SOUTHERN HIGHLANDS REGIONAL SHOOTING COMPLEX
WATTLE RIDGE ROAD, HILL TOP
2015.1173
OFFICE OF SPORT

SUMMARY OF CHANGES

SECTION 75W PLANS

JOB NUMBER	2015.1173
SCALES	1:500 @ A3
SHEET	A201/75W
DRAWN	BC
DATE	JUN 16
REV	(N)

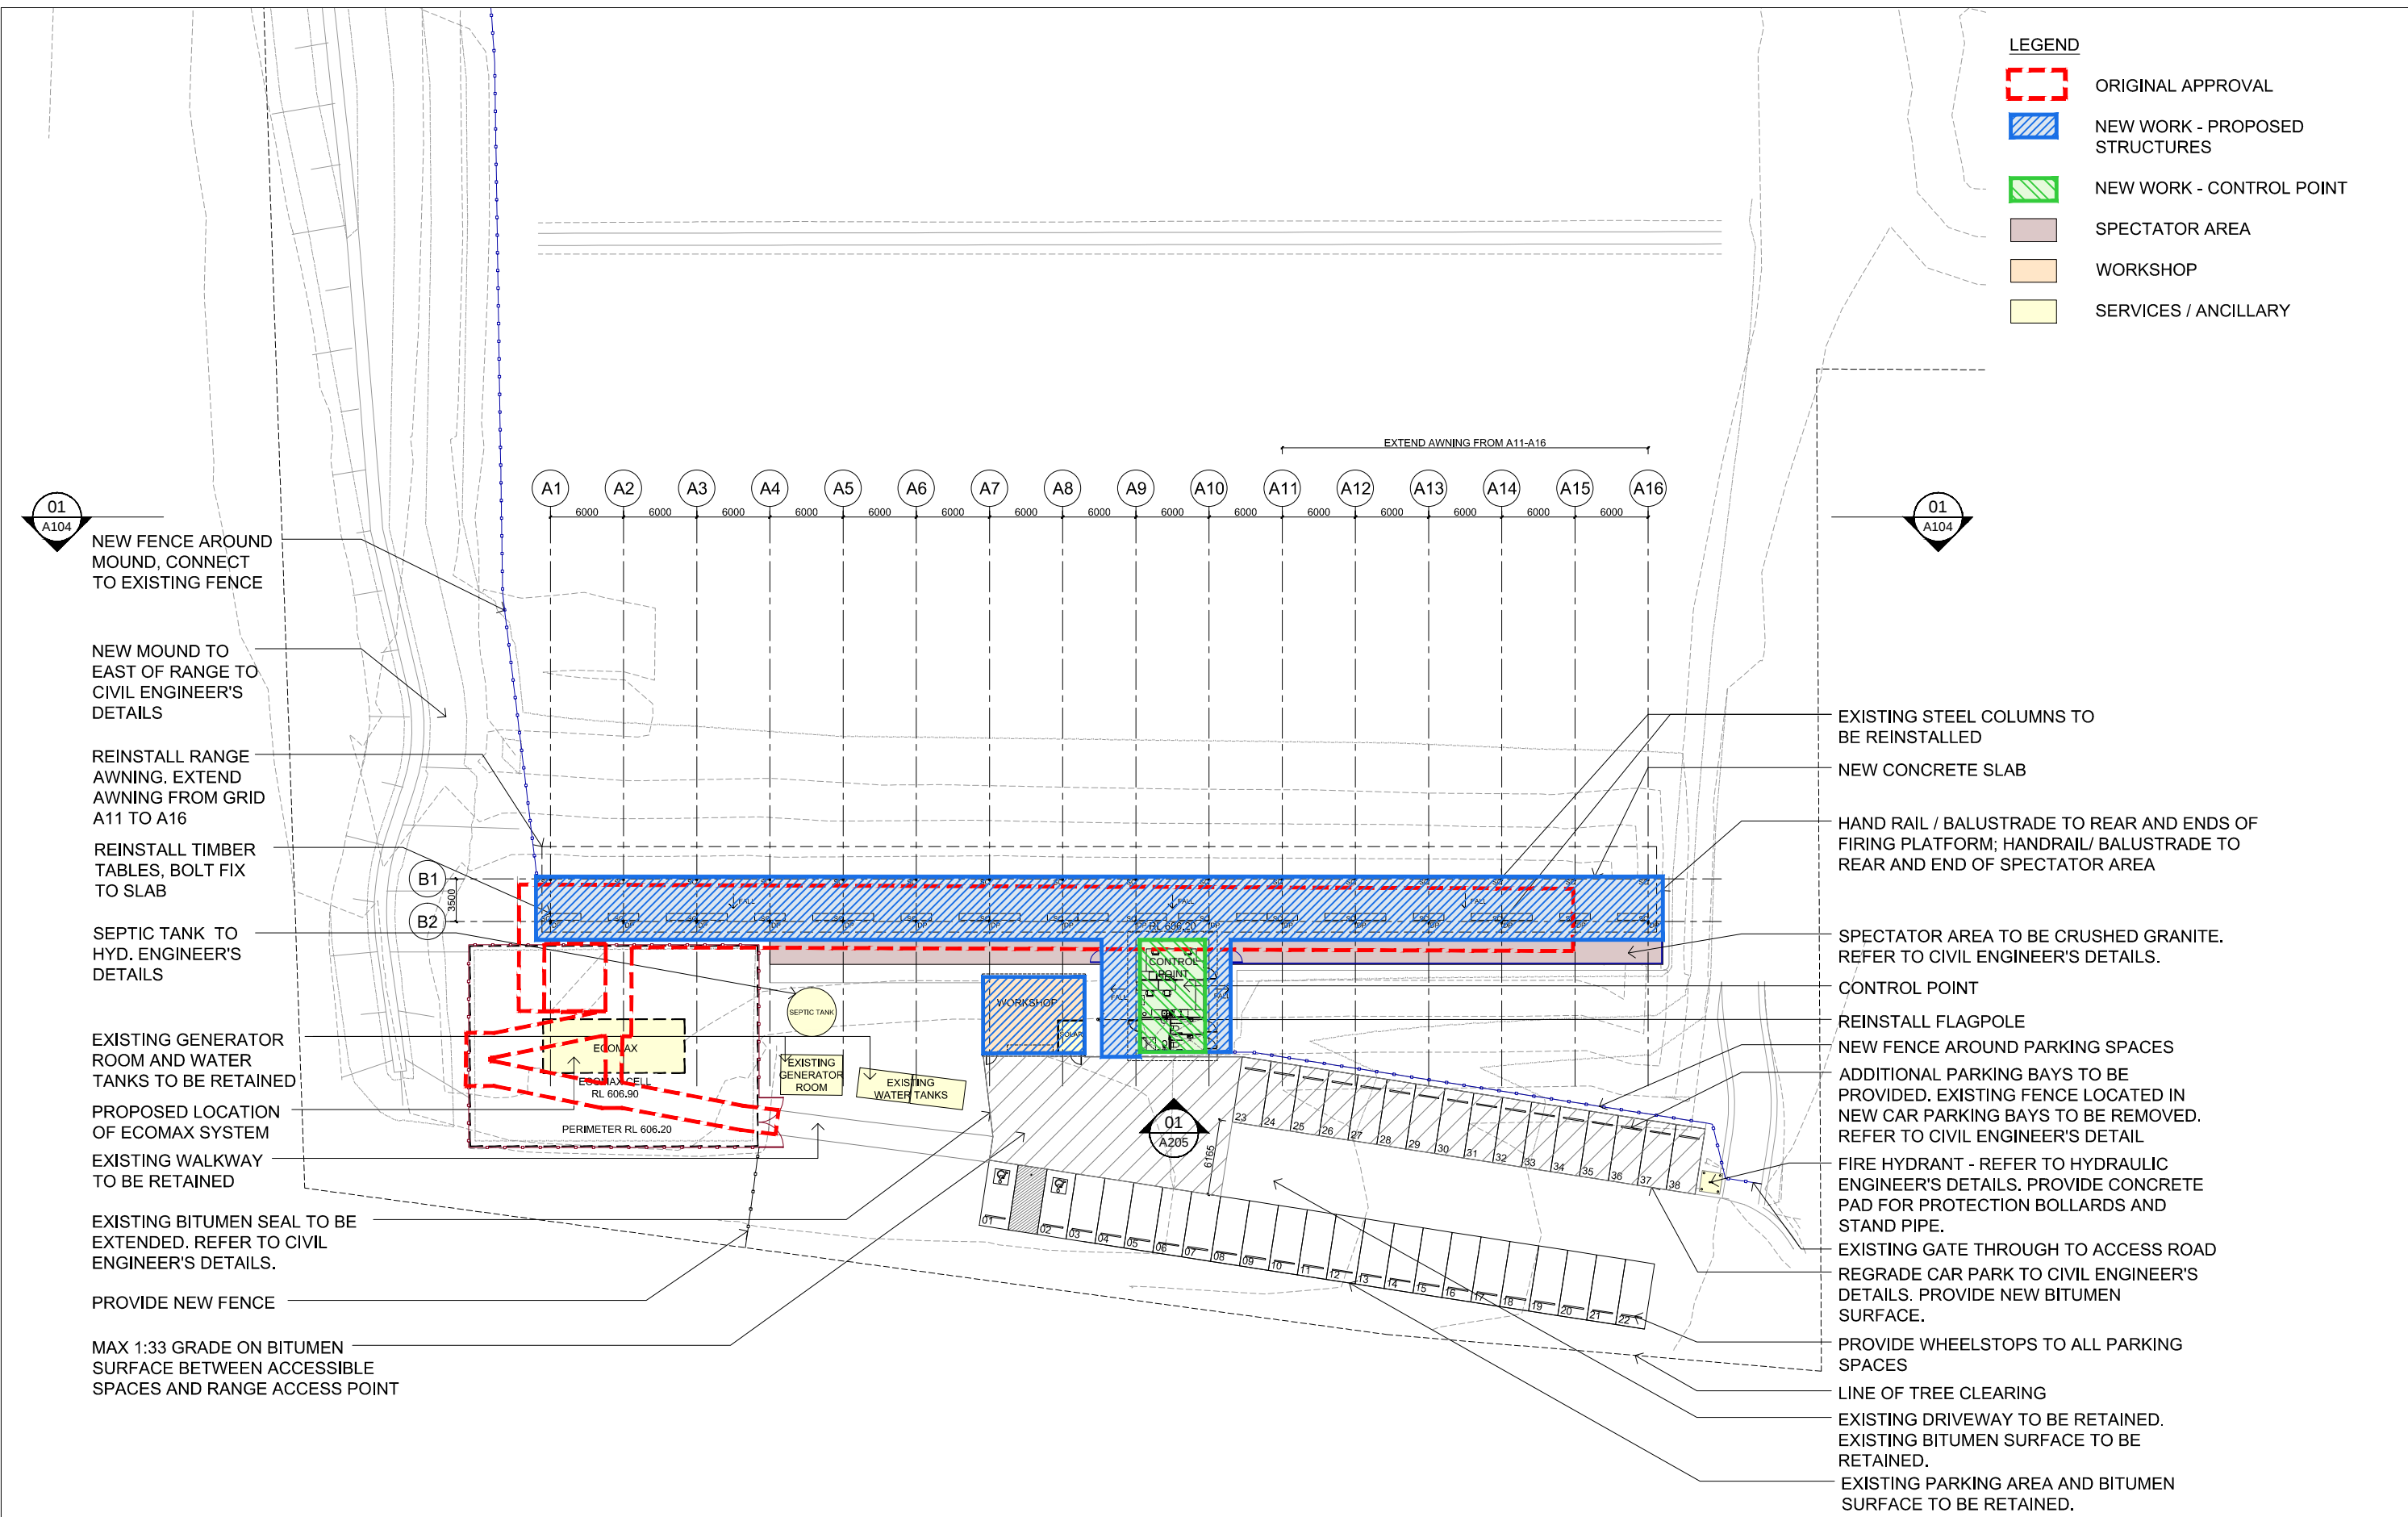
500 METRE RANGE			
NO.	AMENDMENTS	REF. PLAN	NOTES
1	WORKSHOP ADDED	A201	-
2	ECOMAX/ SEPTIC TANK RELOACTED	A201	-
3	CONTROL ROOM RELOCATED	A201	-
4	SOLAR PANELS ADDED	A202	-
5	SHOOTING PLATFORM LOWERED	A205	-
6	SPECTATOR AREA ADDED	A201	-
7	ADDITIONAL PARKING PROVIDED	A201	-
8	RANGE FLOOR REGRADED	A201	-
9	NEW MOUND ADDED	A101, A104	REFER TO CIVIL ENG. DETAIL C-SC-201, 202
10	STOP BUTT ANGLE AMENDED	A101	REFER TO CIVIL ENG. DETAIL C-SC-201, 251

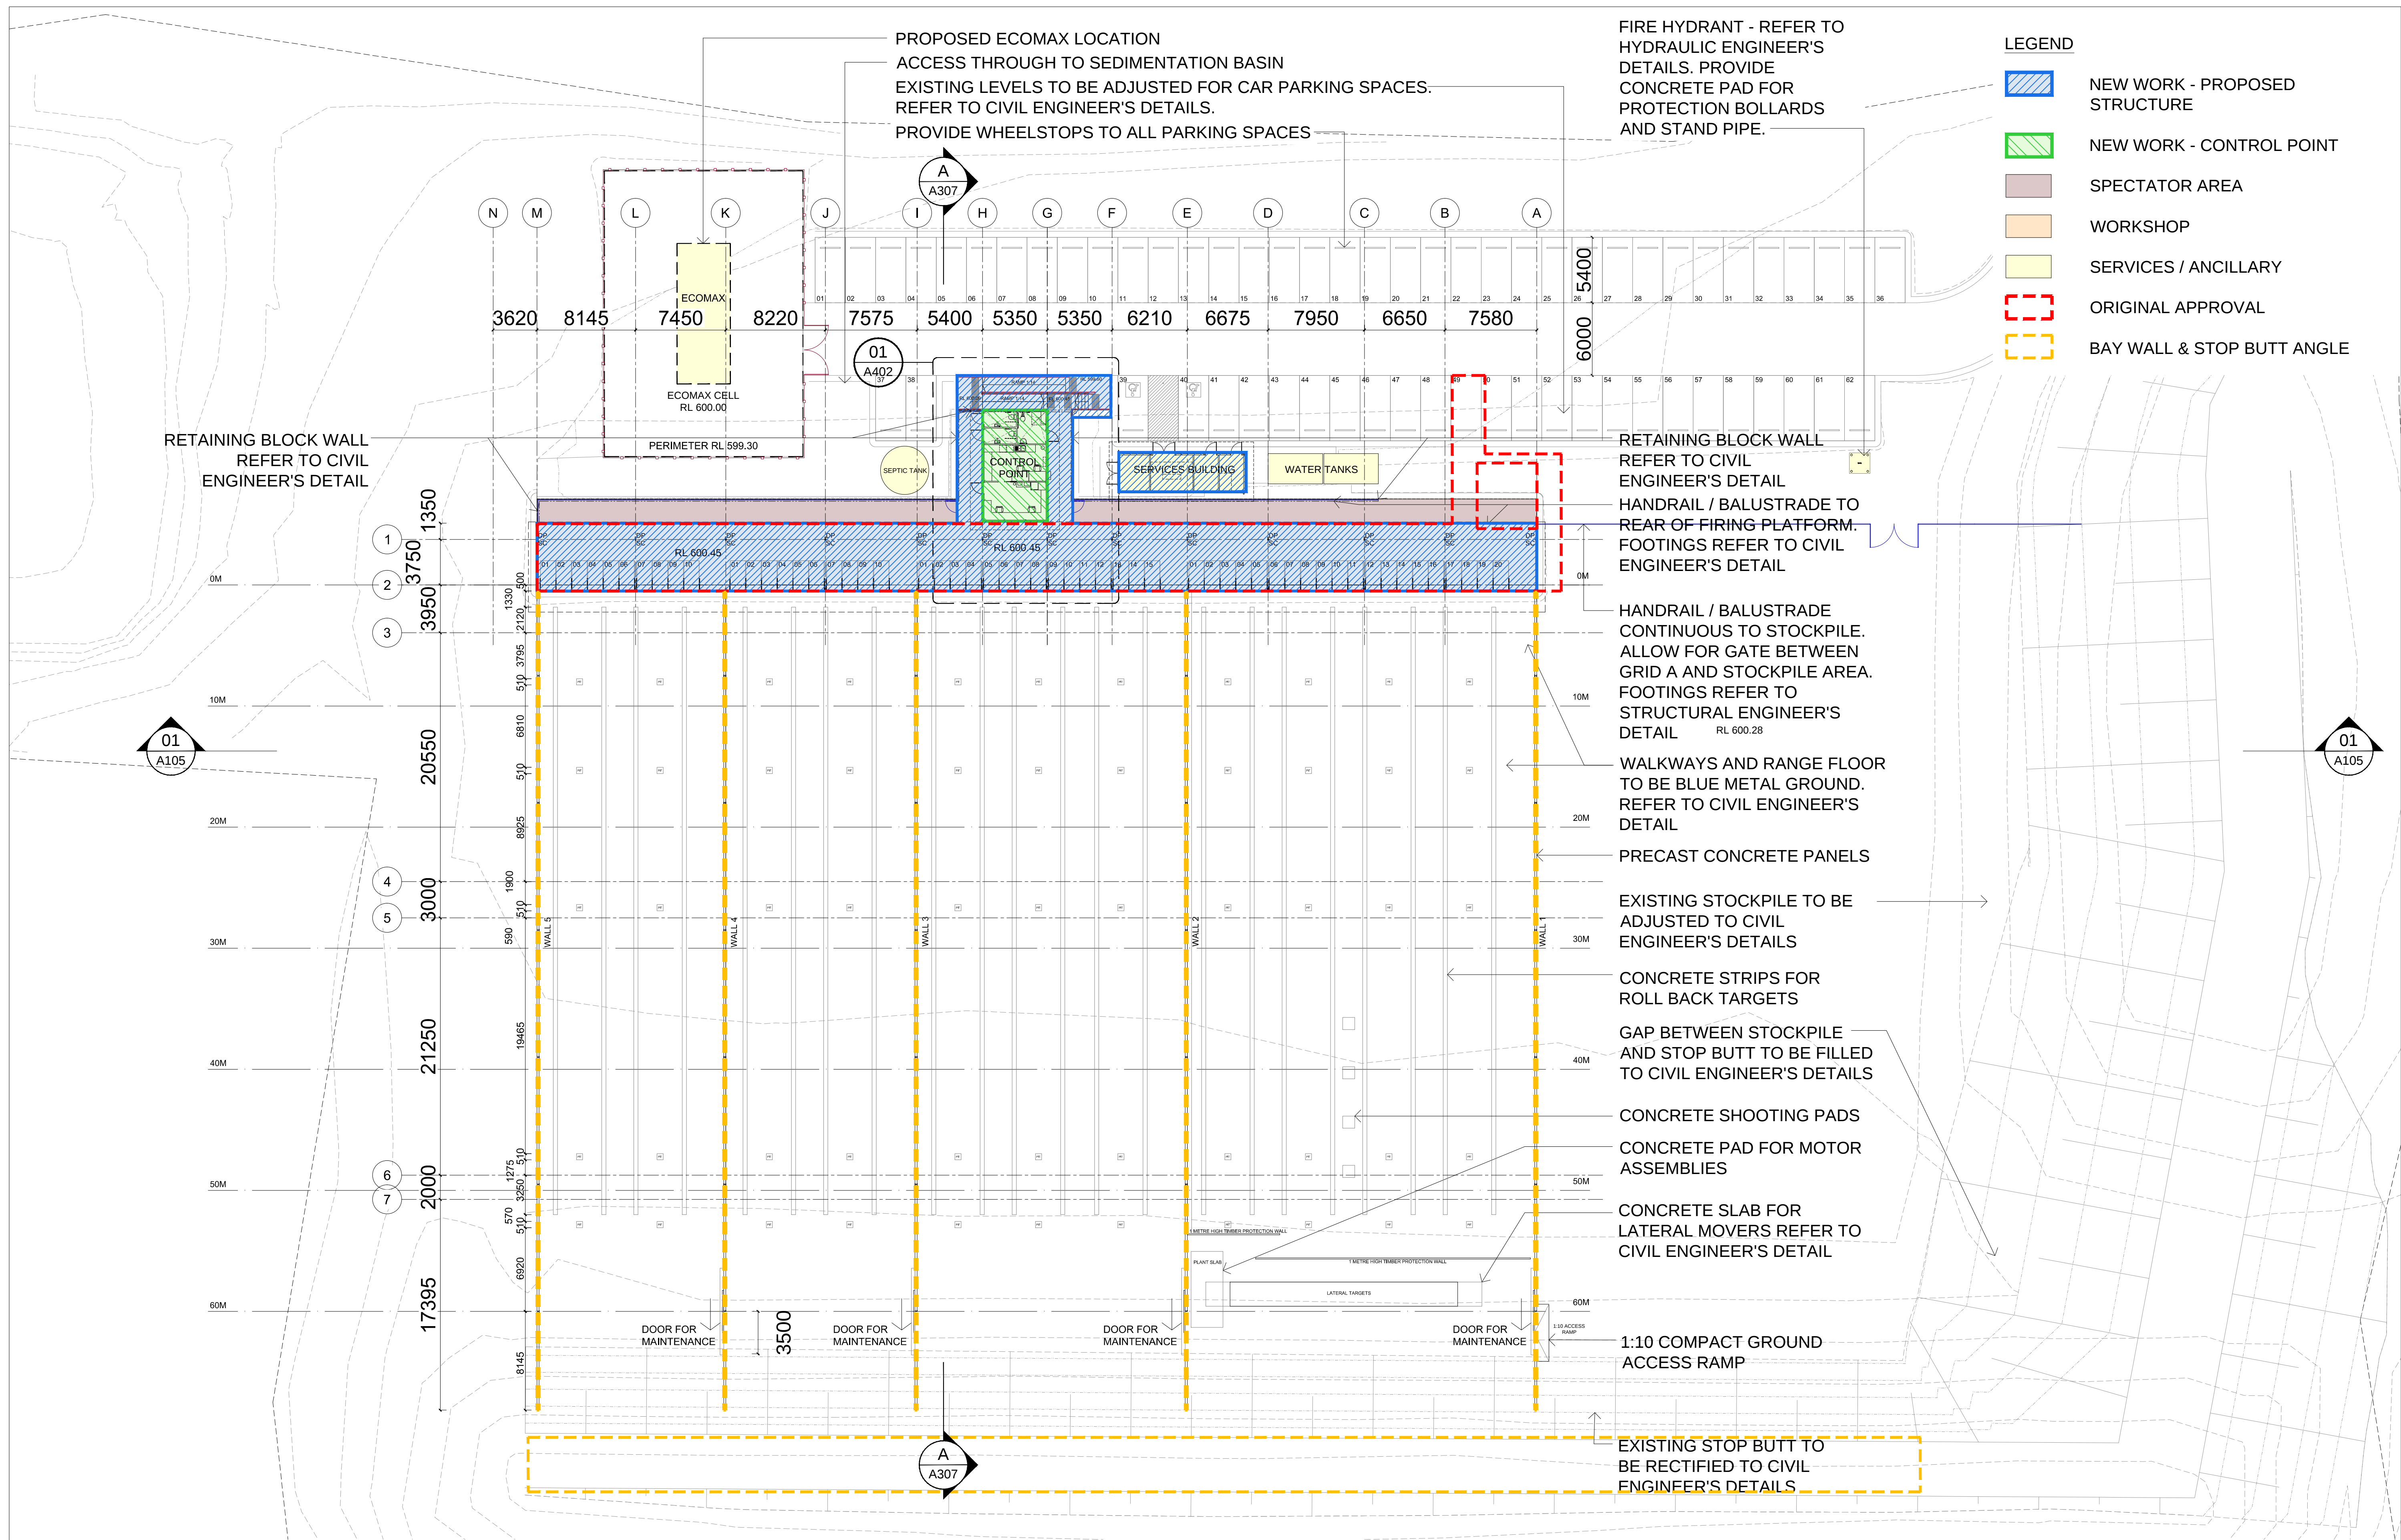
50 METRE RANGE			
NO.	AMENDMENTS	REF. PLAN	NOTES
1	ECOMAX/ WATER TANK/ SCEPTIC TANK ADDED	A301	-
2	SOLAR PANELS ADDED	A302	-
3	SPECTATOR AREA ADDED	A301	-
4	ADDITIONAL PARKING PROVIDED	A301	-
5	RANGE FLOOR REGRADED	A301	-
6	MOUND RESHAPED	A101, A105, A301, A302	REFER TO CIVIL ENG. DETAIL C-SC-203
7	STOP BUTT ANGLE AMENDED	A101, A301, A302, A307	REFER TO CIVIL ENG. DETAIL C-SC-203, 251
